Re: Percolation Testing Support Building Permit
Building Permit # B00147070
16449 Ed Warfield Road

Mariani Property / Historical Home of Ed Warfield
16449 Ed Warfield Road, Woodbine

SITE INSPECTION SHEET

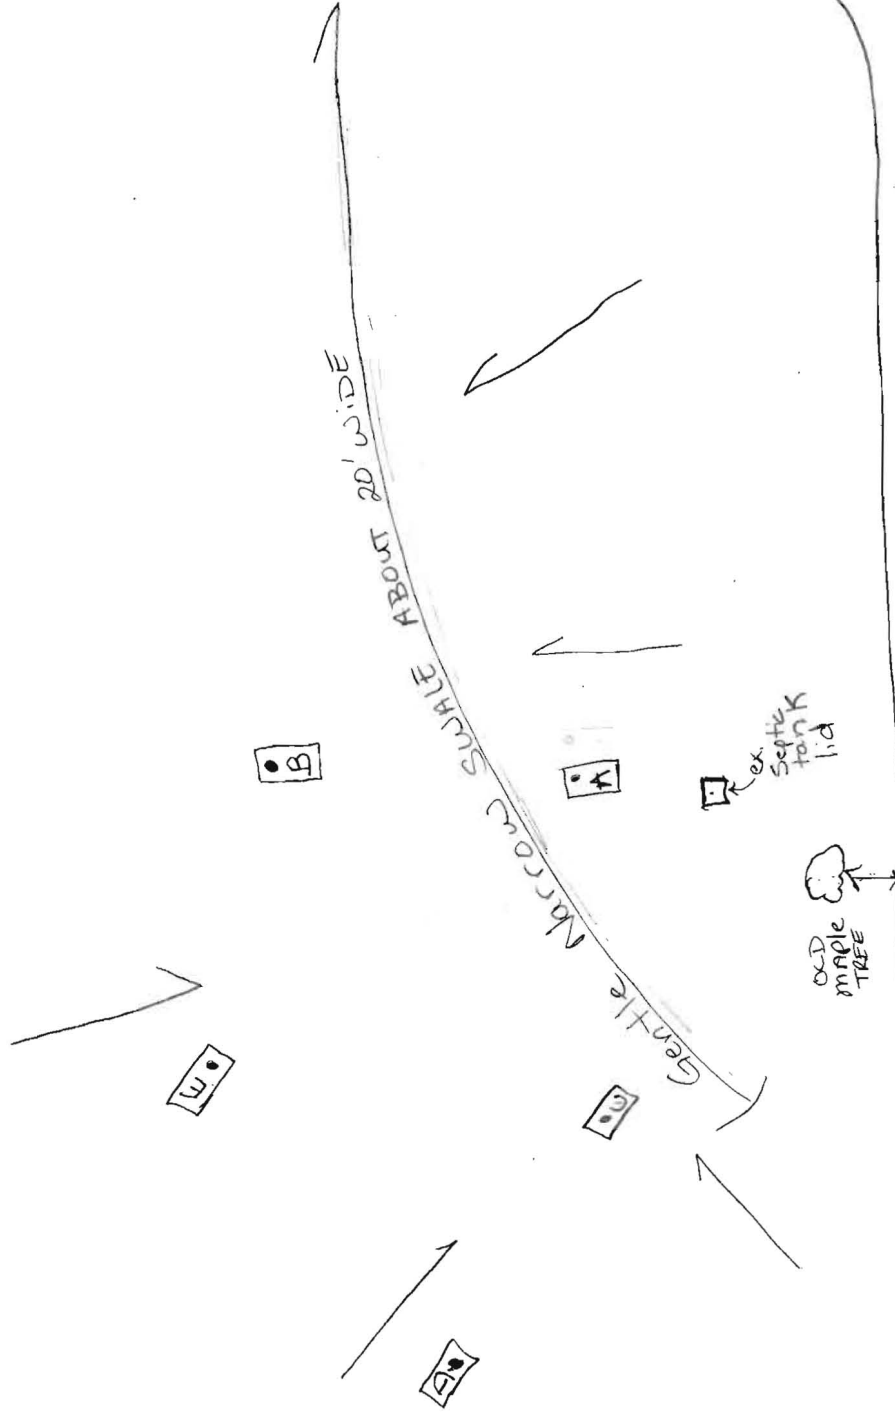
Notes: - Lower elevations typical of 6' clay, water at 12'. (Holes C, D)

- Higher elevations, holes D, E, perc around 3-4' with water around 12-14 feet

- Hole A - no water in bottom @ 14' after 1 1/2 hours +

- Future repair area best near perc holes D, E, & B. - INLET AT 3, bottom at 5.

- 4' Treatment buffer identified.

Rate \bar{x} = 20 min

LOCATION DIAGRAM

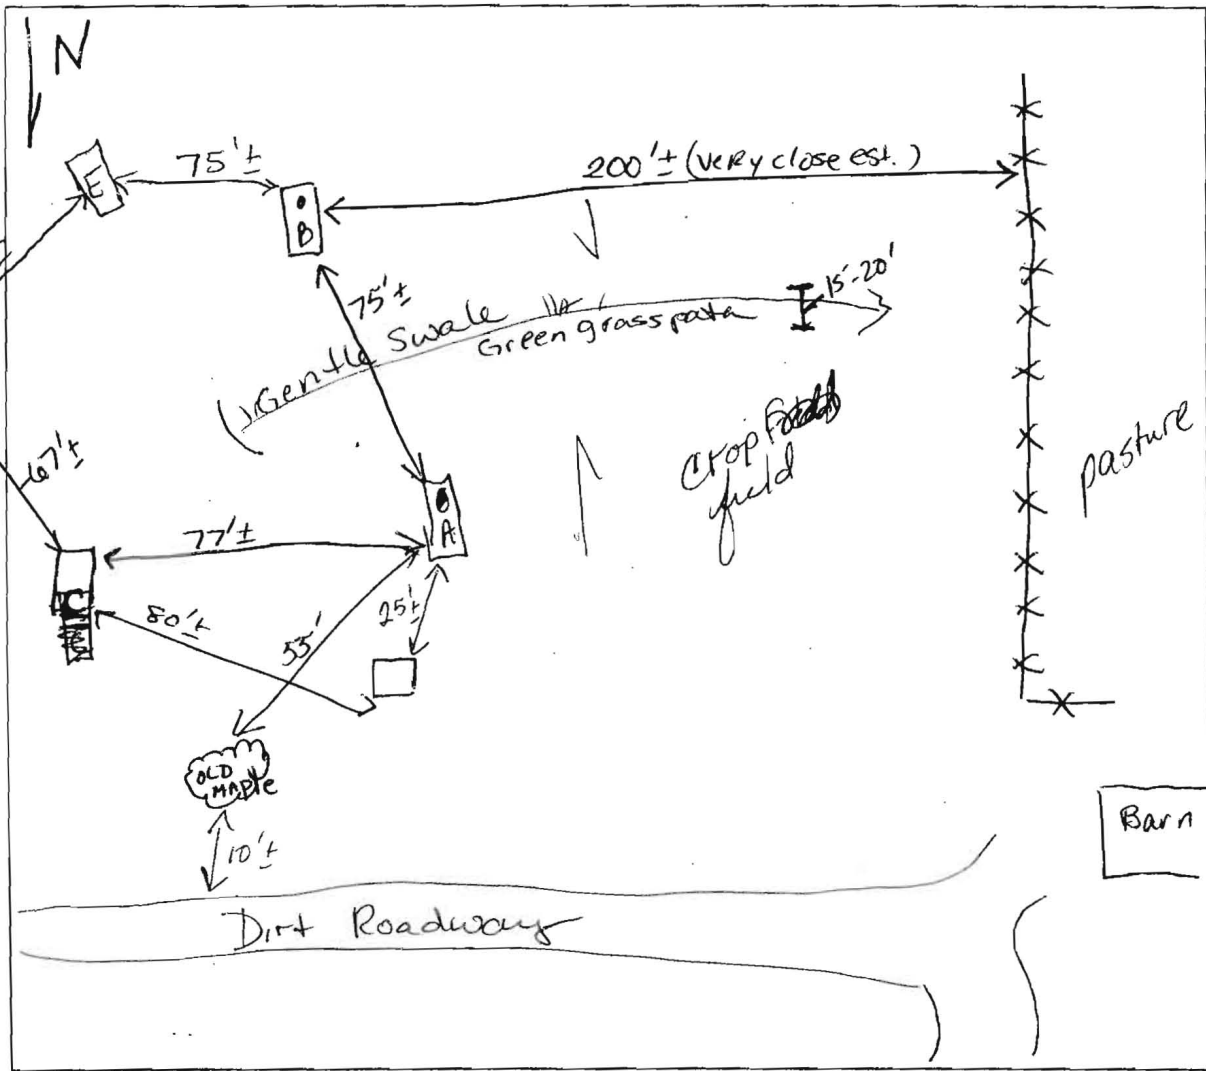
COMMENTS: 4/23/04 Soil descrip. on other pages. Stay SE of Swale for permeable soils at shallower depth (for future repairs). Existing system appears to be functioning.
